1. Refer to footnote 2 on page 1 of the Synapse Report. The footnote refers to some – but not all – interrogatory responses filed in this matter.
 - a. Please confirm that Synapse has reviewed all interrogatory responses from MECL and the PEI Energy Corporation with respect to this matter.

2. Please explain the contingency or contingencies that justify additional on-Island capacity at this time (i.e. disconnection from mainland, extreme weather events, etc.).
 - a. How likely are each of these contingencies to occur?
 - b. Have these contingencies previously resulted in a service interruption or load shedding for MECL customers? If so, please explain the frequency, duration and impact of the interruption.

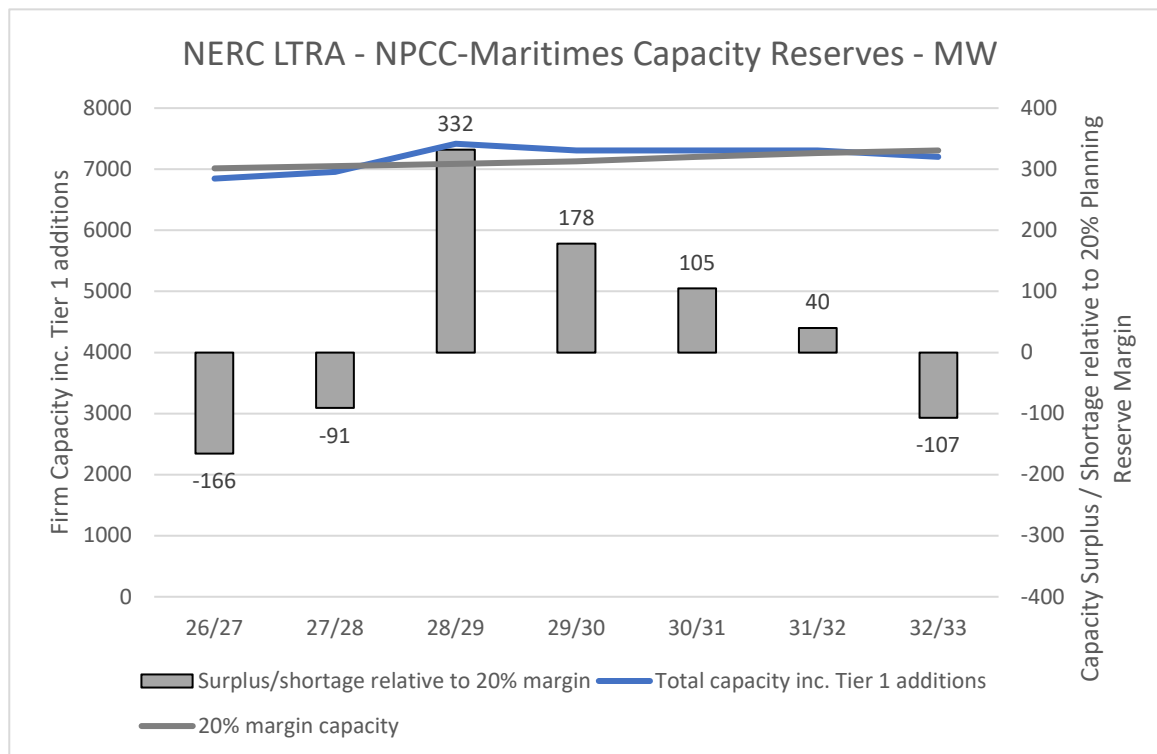
The information contained in the next IR response shows some surplus capacity in the Maritimes region starting with the winter of 2028/29, but the report does not comprehensively convey timing or duration considerations, or actual market availability of such capacity, and thus is not sufficient to support an opinion on the capacity available for purchase.
